SUBDIVISION REVIEW SHEET

CASE NO.: C8-2021-0180.SH

SUBDIVISION NAME: Goodnight Ranch Town Center West - Section One

Exhibit C: Master Comment Report

COVER

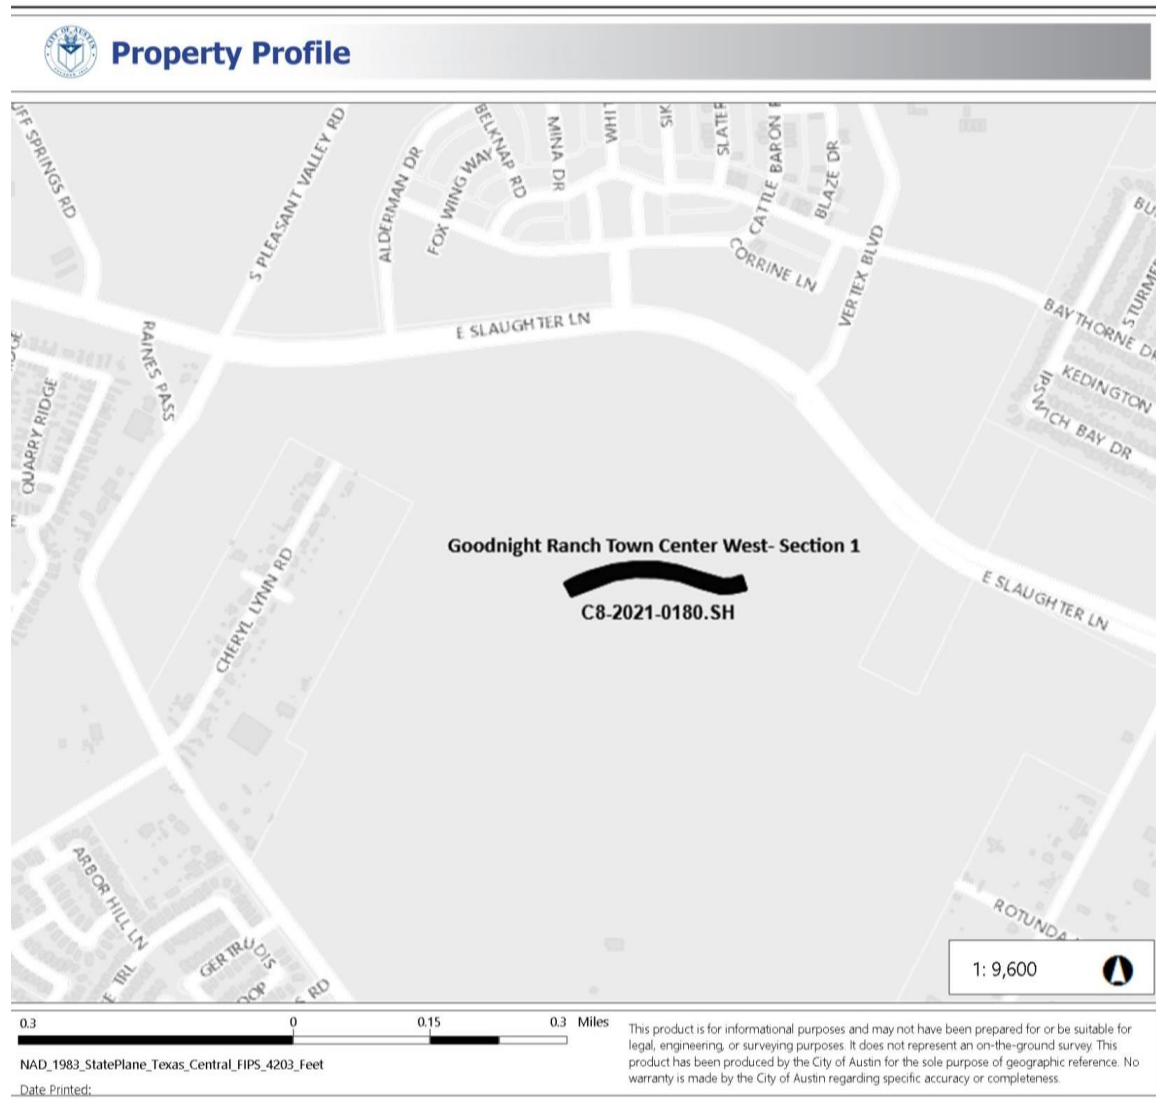
SR1. The cover page should be the first page, the plan diagram should be the second page, with the notes, signatures, and other information on the final page(s). (25-1-83)

SR2. On the location map on the first sheet please include major roads to help locate this proposed road within the city (25-1-83)

SR3. Notes 1, 2, and 4 on the first sheet appear to be repeating information already on the plan please remove these notes, and move the remaining notes with the other notes in the plan (25-1-83)

SR4. Please add all of the PUD Ordinance numbers to note 3 on sheet 1 and add "as amended" after "of the City of Austin" (25-1-83)

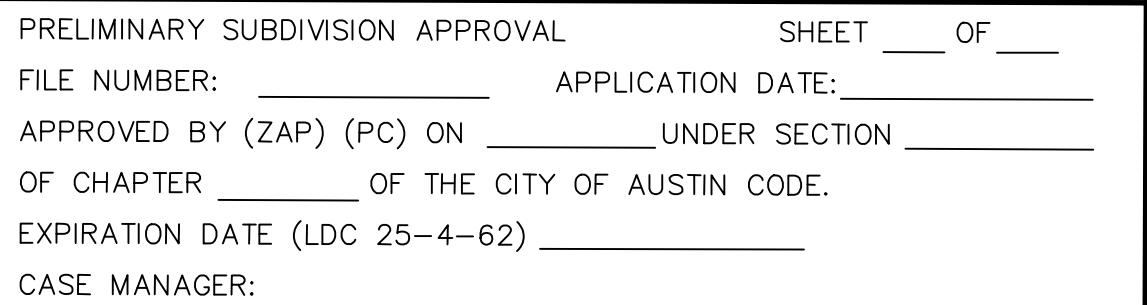
SR6. Is the Type A Diagram on sheet 2 referencing the "A Neighborhood Center Boulevard" in the Goodnight Ranch PUD 2006116-053 in the Street Cross Section Table Exhibit H? If so, it looks like there needs to be an 8 foot median in the center of the street?

SR7. If the Type A Diagram on sheet 2 is referencing the "A Neighborhood Center Boulevard" in the Goodnight Ranch PUD 2006116-053 in the Street Cross Section Table Exhibit H, please update the "Streets:" chart on sheet 2 to reflect Exhibit H in the Goodnight Ranch PUD 2006116-053

SR8. Please remove Appendix Q1 and Q2 and the impervious cover tracking tables from sheet 2 of the plan instead please provide these as separate exhibits or move them to the final page of the plan (25-1-83)

SR9. Please remove the text "Austin Energy Notes" from sheet 2 and incorporate these notes into the Preliminary plan notes (25-1-83)

OVERALL LAYOUT
GOODNIGHT RANCH
TOWN CENTER - SECTION ONE
PRELIMINARY PLAN

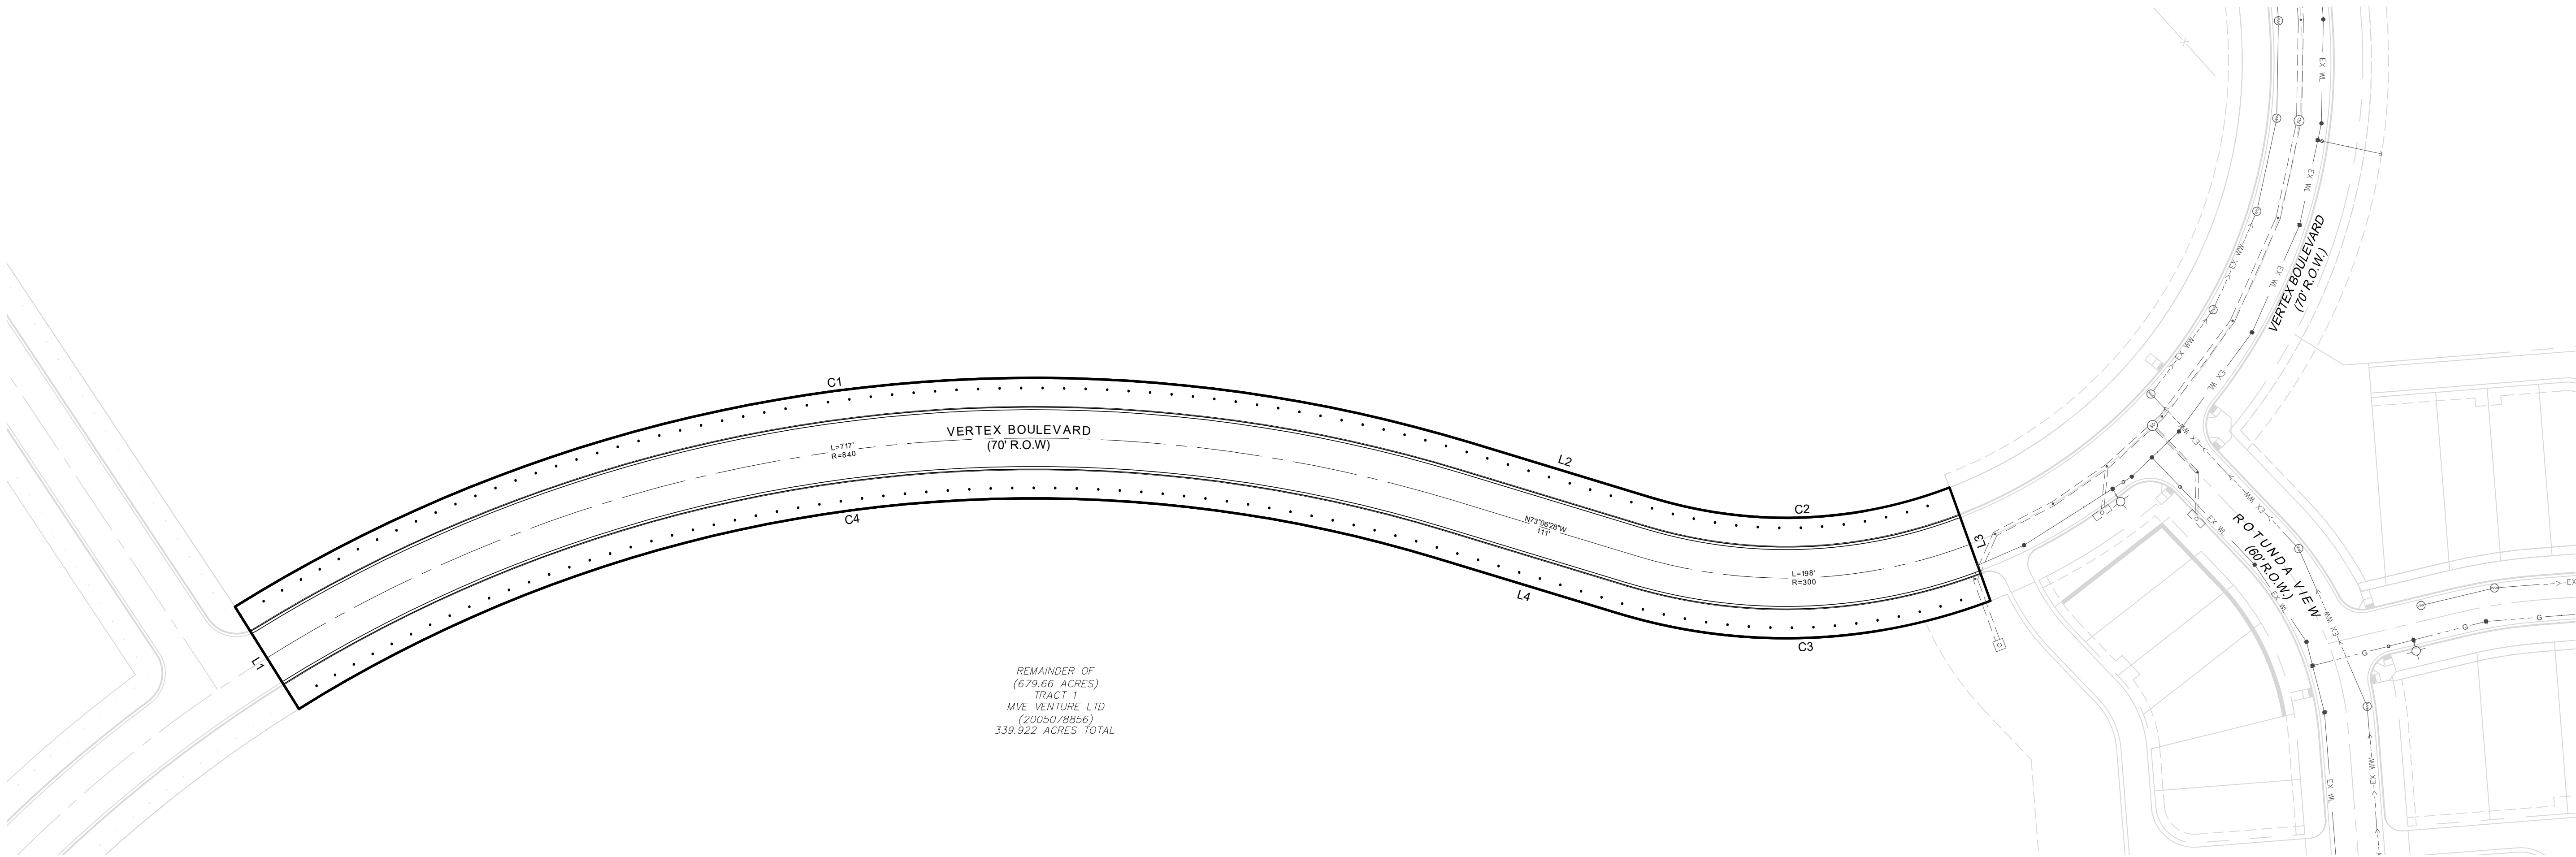
ATD1. Sidewalks are required on both sides of Vertex Blvd. Identify the location of the sidewalks by a dotted line on the preliminary plan and **include the sidewalk symbol within the Legend**. LDC 25-6-351. TCM, 4.2.1.

ATD2. Dead-end streets that are stubbed out for future extension to the adjacent property must terminate in an open-ended cul-de-sac if the dead-end street is more than 150 feet long. LDC 25-4-152; TCM, 1.3.2.E. Provide an open-ended cul-de-sac with a right-of-way radius of 60 feet at the end of Vertex Blvd.

ATD4. The cross-section provided for Vertex Blvd only complies with the PUD and TCM street criteria by identifying 5' easements outside of the area included in this application. Update the Shared Use Paths to be within the proposed right of way dedication or extend the limits of the application to include the property on which all easements are proposed. LDC 25-1-83, LDC 25-6-351.
